SERVICETEKNOTES

TABLE OF CONTENTS

7D02 HOT PLUGGING PERSONALITY MODULES DAMAGES A07U7010 (cont.)

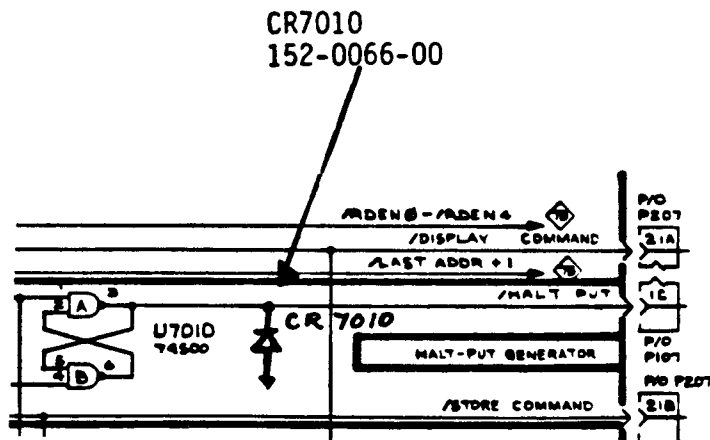
When inserting a personality module into a powered up 7D02 (hot plugging) it is possible to destroy or damage A07U7010. This will happen if the personality module is off center when hot plugged causing one of its conductors to short Pins 59 (-15 volts) and 61 (/halt put) of A01J8005. This effectively shorts the Pin 3 output of A07U7010 (/halt put) to the -15 volt supply.

To protect A07U7010 Mod #M46091 was implemented at Serial Number B021911. It places a protection diode, CR7010, 152-0066-00, between U7010-3 and ground (see included partial schematic 7A).

This diode should be added on the back of A07 with its anode soldered to U7010 Pin 7 and its cathode to U7010 Pin 3.

Figure 1 - ECB Layout
C6 Added

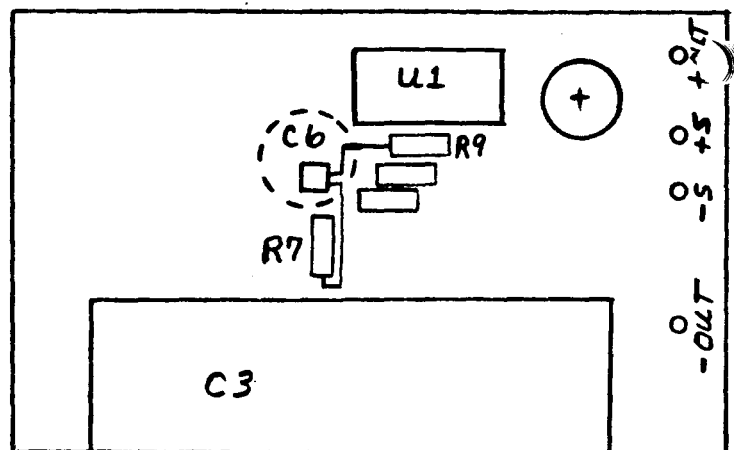
The PRAM -2 Volt Power Supply (P/N 119-0873-01) is mounted on the rear air duct housing of an 1803, 1804, or 1805 test station. The -2 Volt supply may oscillate at about 40 kHz with an amplitude of 200mV to 400mV. These oscillations may cause intermittent failures of the PRAM Option Verdict tests. Note that not all 119-0873-01 supplies will exhibit oscillations or instability.

Power Supply part number 119-0873-01 changes to -02 with the addition of capacitor C6. The 119-0873-02 is a direct replacement for the 119-0873-01.

Add: C6 1 each 283-0341-00 Cap,
0.047uf, 10%, 100V

Capacitor C6 should be installed between the -out and U1 pin 5 points. Insulation sleeving should be placed on the C6 leads to prevent shorting.

1804 VOLUME 2 MANUAL CORRECTION, FIGURE 5
REAR

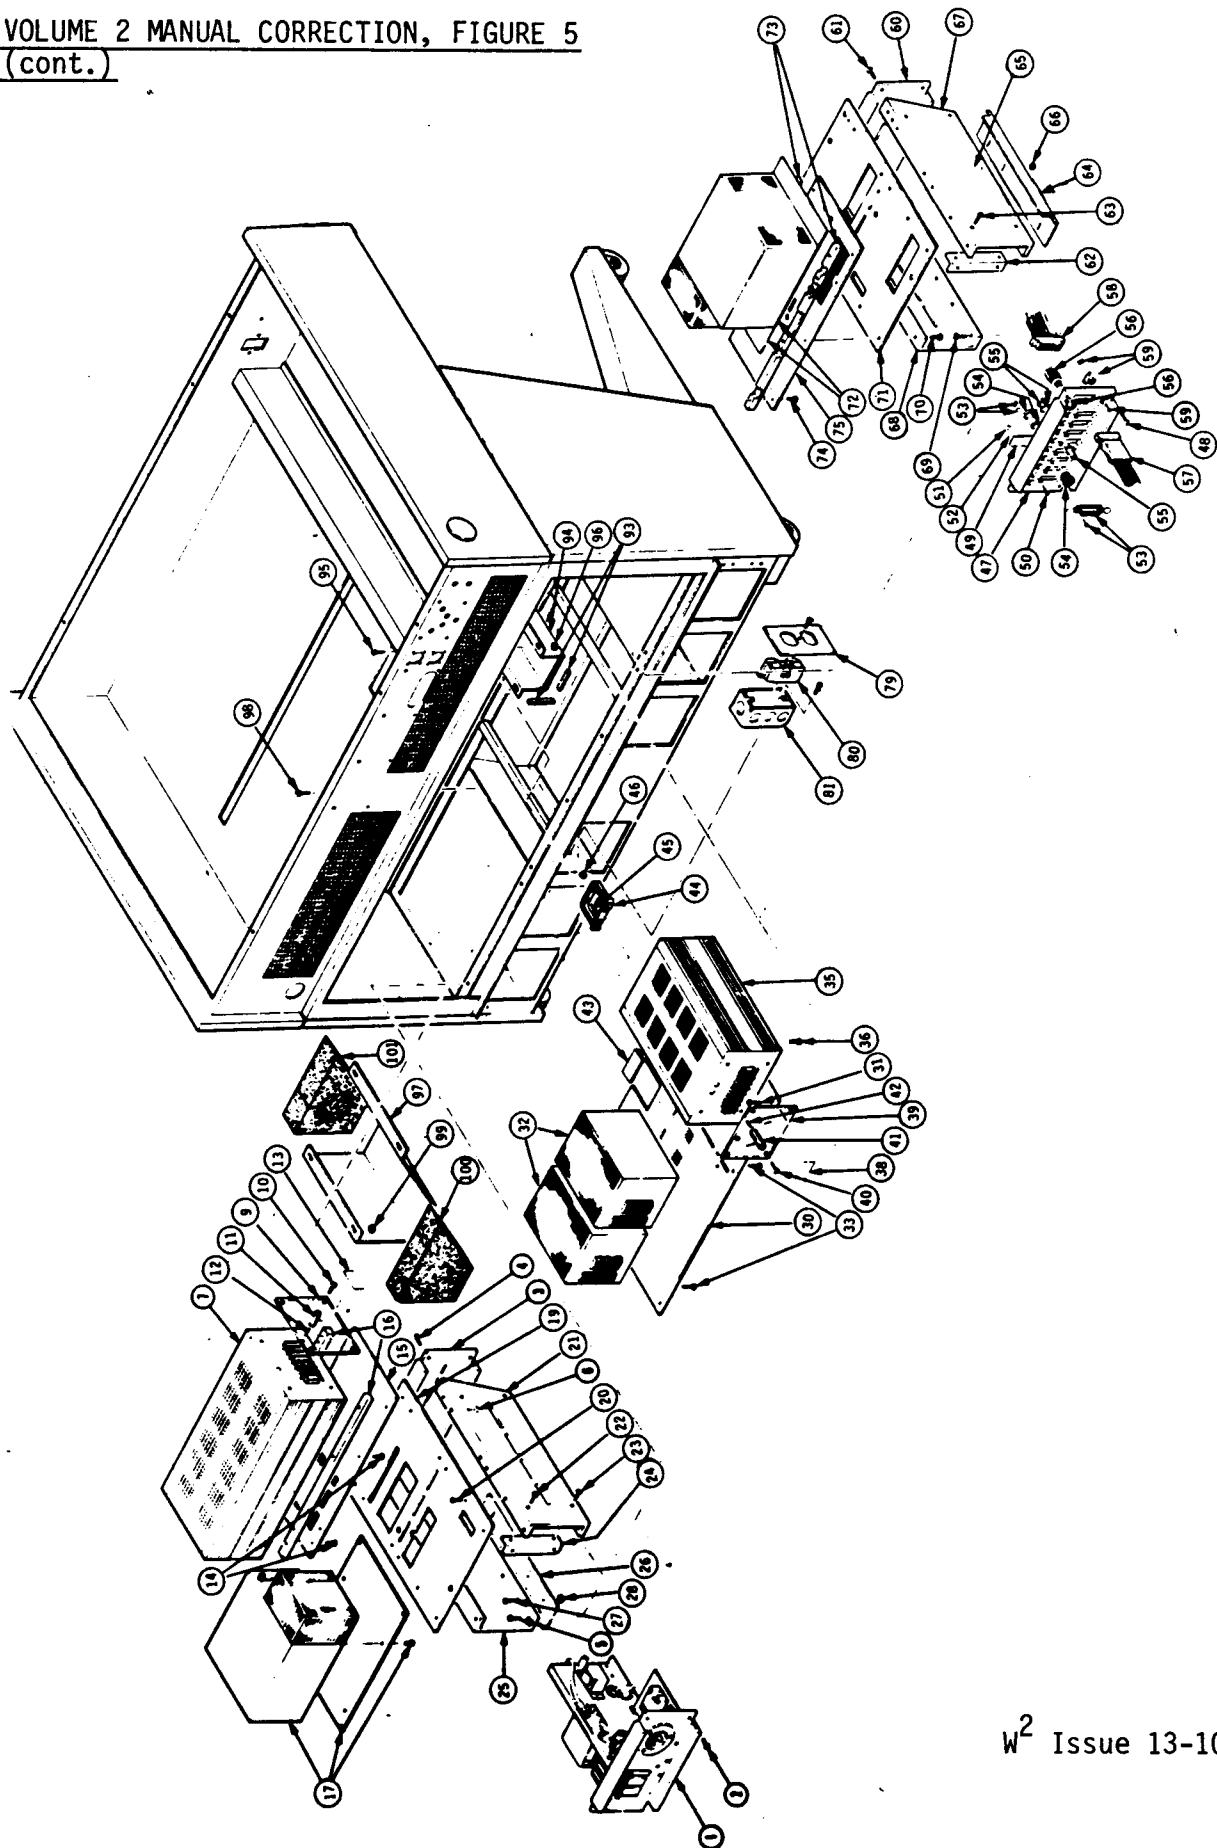
The index numbers in the mechanical view, Figure 5 Rear, do not match the replaceable Mechanical Parts List on pages 6-99 through 6-103. Attached is a mechanical view, Figure 1, which contains the correct index item numbers. Index numbers 8, 13, 18, 24.1, 24.2, 29, 34, 37, 76, 77, 82, 83, 84, 85, 86, 87, 88, 89, 90, and 91 are listed in the replaceable parts list, but are not shown in Figure 5.

The part number listed for index number 5-54 is incorrect. It should be 131-1011-00. For reference purposes only, one should add a note that the mating connector is P/N 131-1012-00 (not shown).

FIGURE A

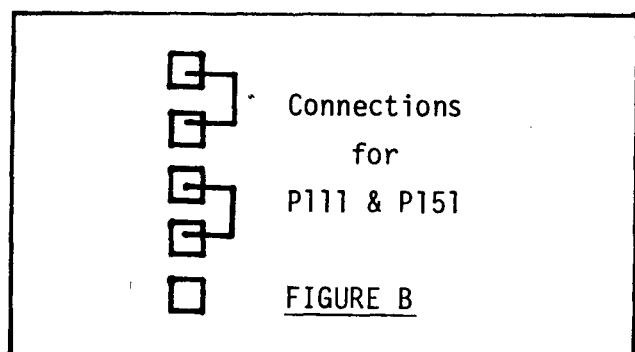
The suggested placement for these parts is in the Opt. 2 ROM/PROM board, A38, 672-1050-00, using the sockets labeled U111 for 160-1668-00 and U151 for 160-1669-00 (see Figure A).

Figure B illustrates the proper connections of P111 and P151 for these parts. Table 1 gives the SYSTEST FIRM listing that will result from the installation of this kit. Table 2 gives the Directory listing of the files that will be present with this kit.

A36 ROM/PROM
 Applications, NTSC, Opt. 1, Assy. B
 672-0939-00 with Patch PROM's Installed

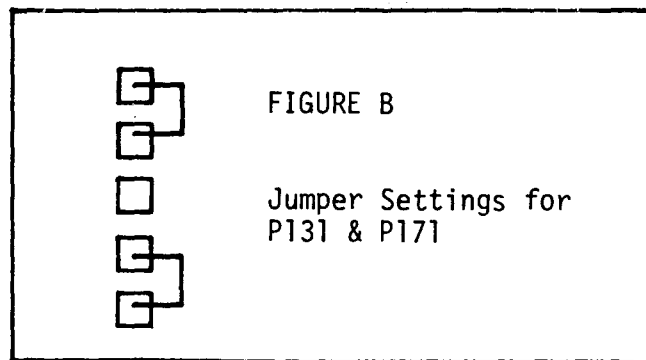
The suggested installation for these parts is to put them into the ROM/PROM NTSC Assembly B board, A36, 672-0939-00. Put P/N 160-1666-00 in the socket for U131 and P/N 160-1667-00 in the socket for U171. Figure A illustrates the configuration of 672-0939-00 with these two new parts installed. Figure B illustrates the required jumper settings for P131 and P171 when these parts are installed.
